RE: **Highland on Conway (Delmar Gardens III) SDP:** A Site Development Plan, Tree Stand Delineation, Tree Preservation Plan, Landscape Plan, Lighting Plan, and Architectural Elevations for a 5.292 acre tract of land zoned "PC" Planned Commercial District located on the north side of North Outer 40 Road, east of Chesterfield Parkway East.

Planning Commission Staff Report

Description: **Highland on Conway (Delmar Gardens III) SDP:** A Site Development Plan, Tree Stand Delineation, Tree Preservation Plan, Landscape Plan, Lighting Plan, and Architectural Elevations for a 5.292 acre tract of land zoned “PC” Planned Commercial District located on the north side of North Outer 40 Road, east of Chesterfield Parkway East.

Re: Delmar Gardens III

Sheet Title: Tree Preservation Plan
 Sheet No: TPP-1
 Date: 06/03/15
 Job #: 660,044

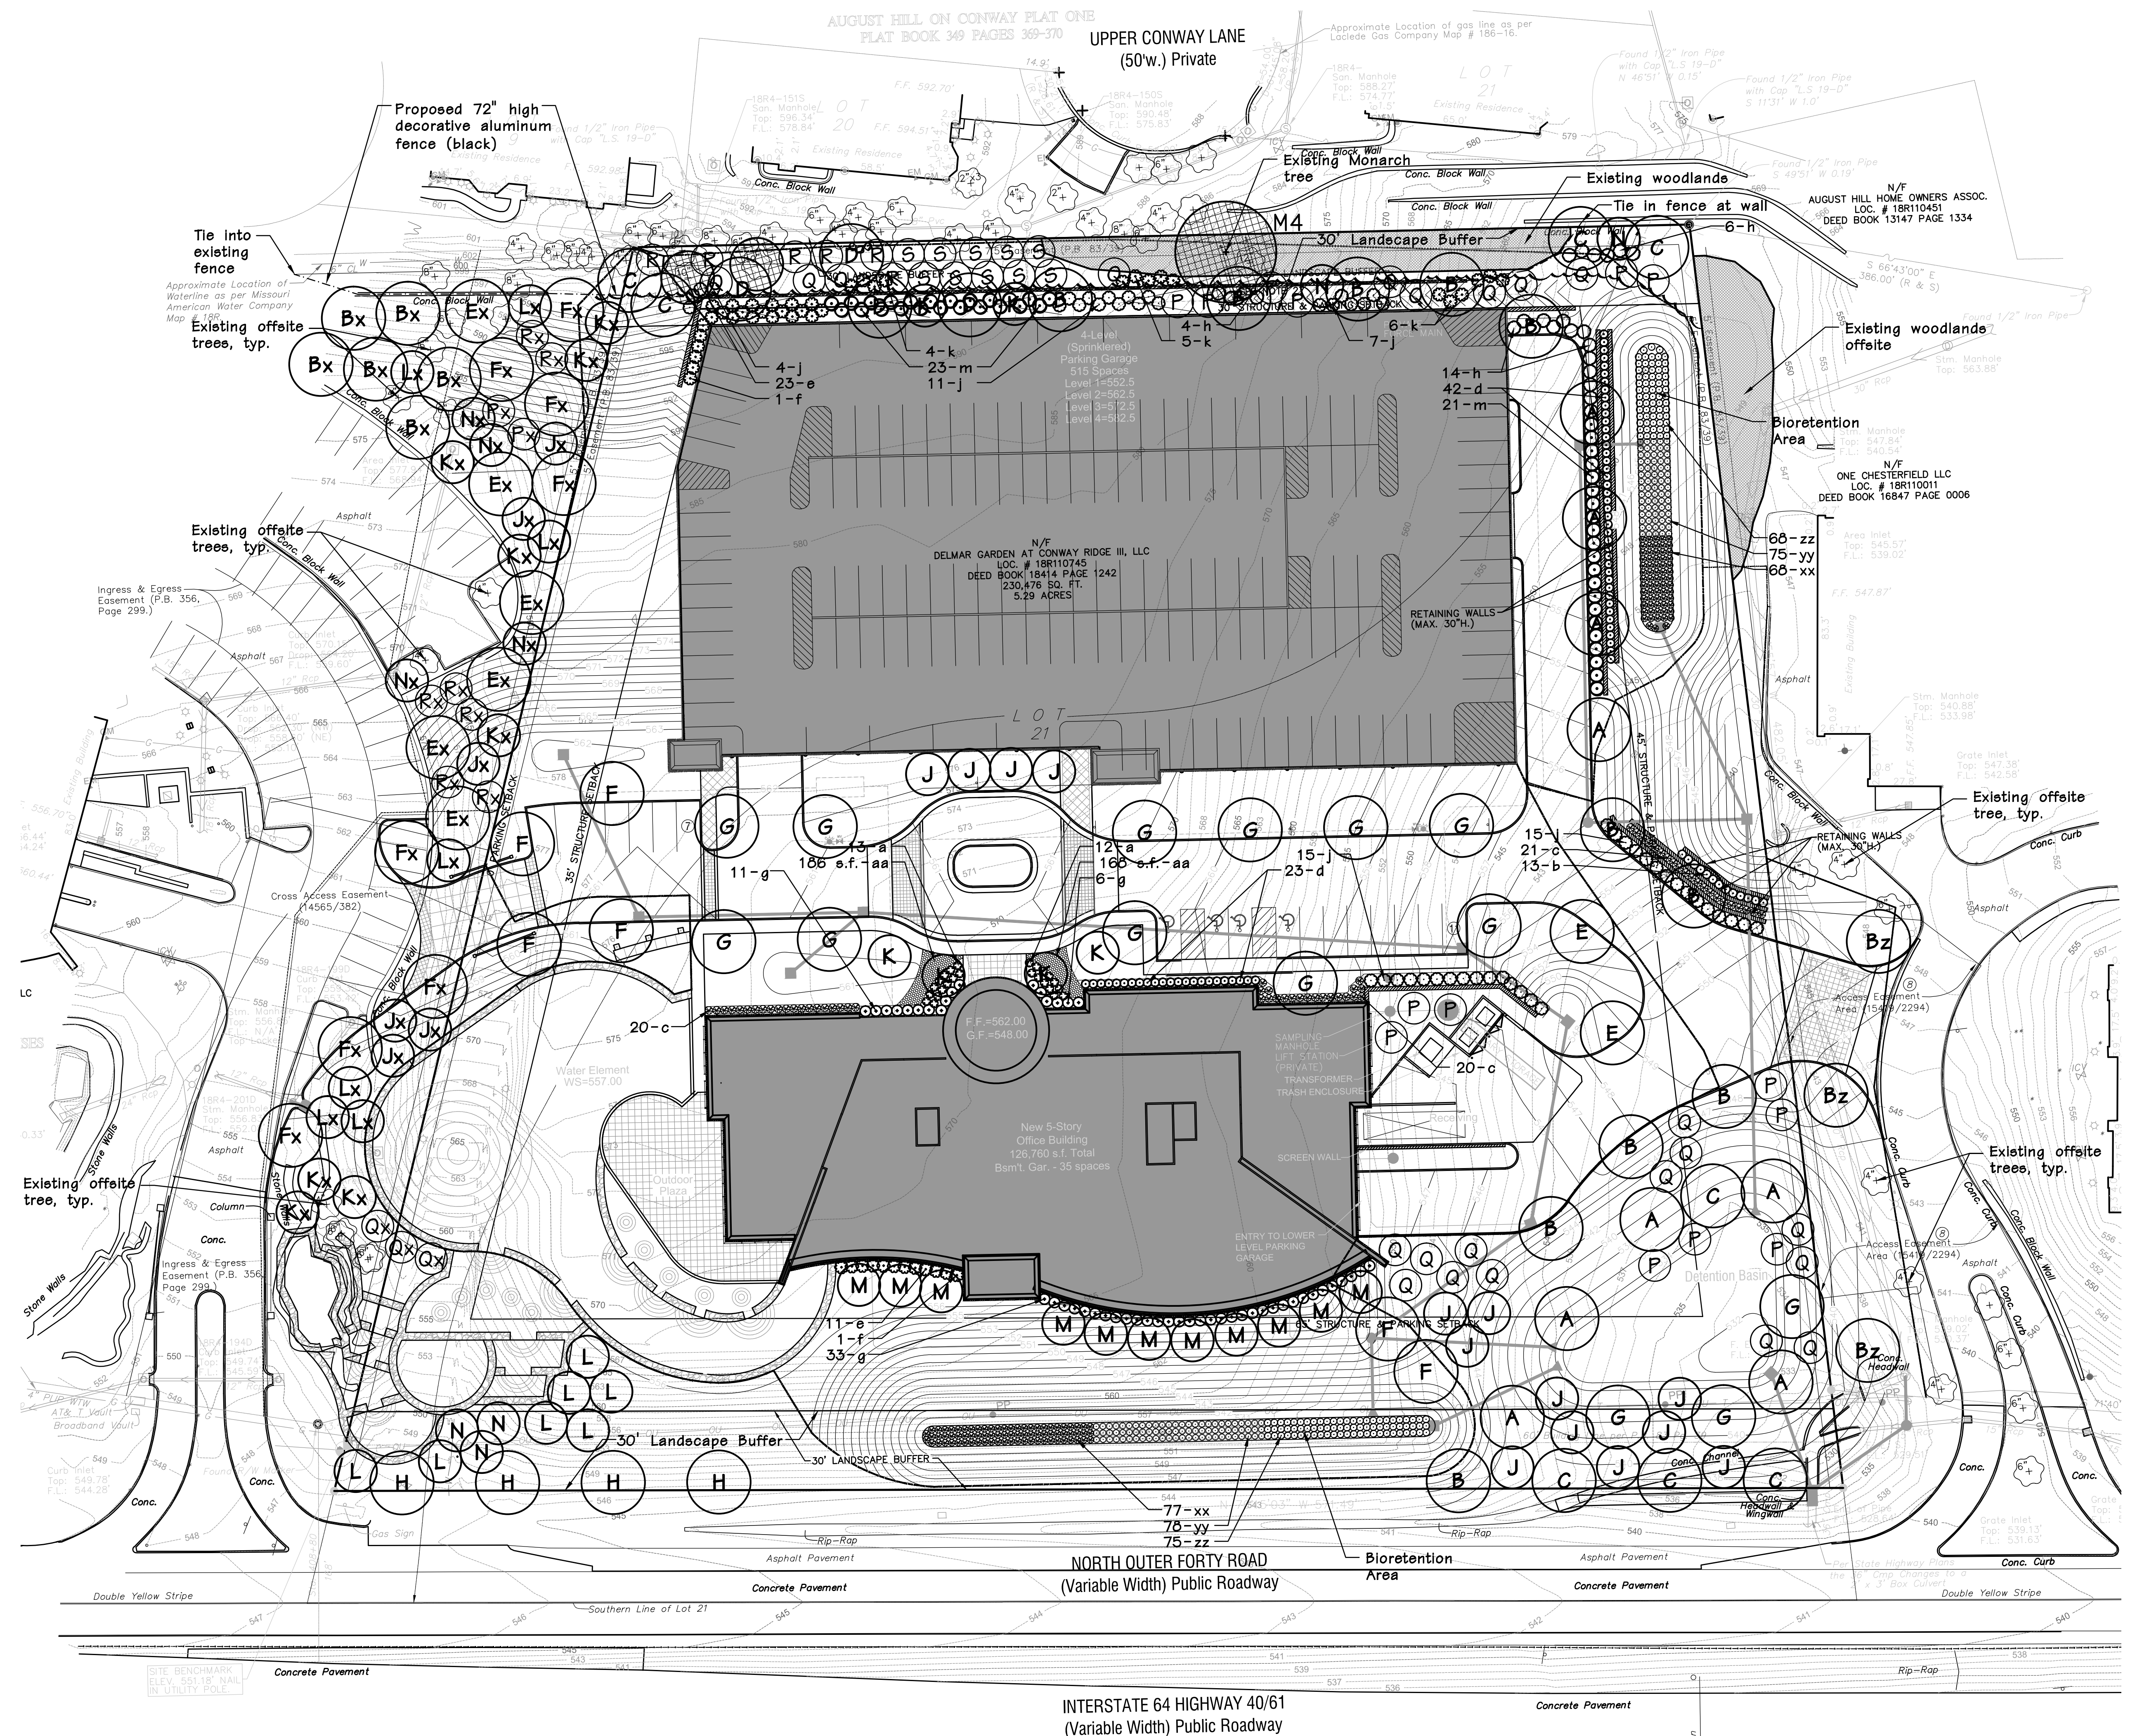
At the August 24th, 2015 Planning Commission meeting, the plans were presented with a Staff recommendation for approval. After discussion occurred, a motion to postpone the vote on the proposed site development plan passed by a vote of 9-0. Additional information regarding heights of architectural elements, the potential for leaving more ground undisturbed in the proposed buffer, and the potential for preserving more trees in the buffer area was requested by the Planning Commission.

6. The Proposed Ornamental fence has been relocated inboard on the subject property where the applicant will have full access to construct and maintain the fence.
7. We have edited the notes on the Tree Preservation Plan to limit work in the Preservation areas.

The applicant resubmitted plans that revised the proposed two tier retaining wall system near the northern property line to a taller single tier retaining wall. The result of this change was the ability to preserve more of the existing grade and the preservation of two additional trees. By preserving more of the existing grade, this placed the proposed landscape buffer at a higher elevation thus providing for an overall taller landscape screening. Additionally, the applicant included 10 additional 12-14' tall Colorado Blue Spruce trees to the northern buffer in an effort to provide a more substantial visual screening of the site from the

The Landscape Plan proposed at the August 24, 2015 Planning Commission meeting met all requirements of City Code. The current proposal introduces minimal changes to the previous plan and these changes are discussed in further detail by the applicant in the attached Applicant Narrative. The largest change is a result of changing from a two-tier retaining wall system to a taller single-tier wall. This will allow for the developer to use the higher existing grades along the northern property line as the basis for the proposed landscape buffer. Another result of preserving the existing grade is that the developer is proposing to preserve two additional individual trees that were previously identified for removal.

In addition to using the existing grade to provide a taller buffer, the applicant has also proposed new evergreen trees that exceed the City Code's height requirements. The City requires that evergreen trees be planted at a height of 6'-8'; whereas, the developer is proposing a number of Colorado Blue Spruce to be planted at a height of 12'-14'. This is also discussed in the attached Applicant Narrative.
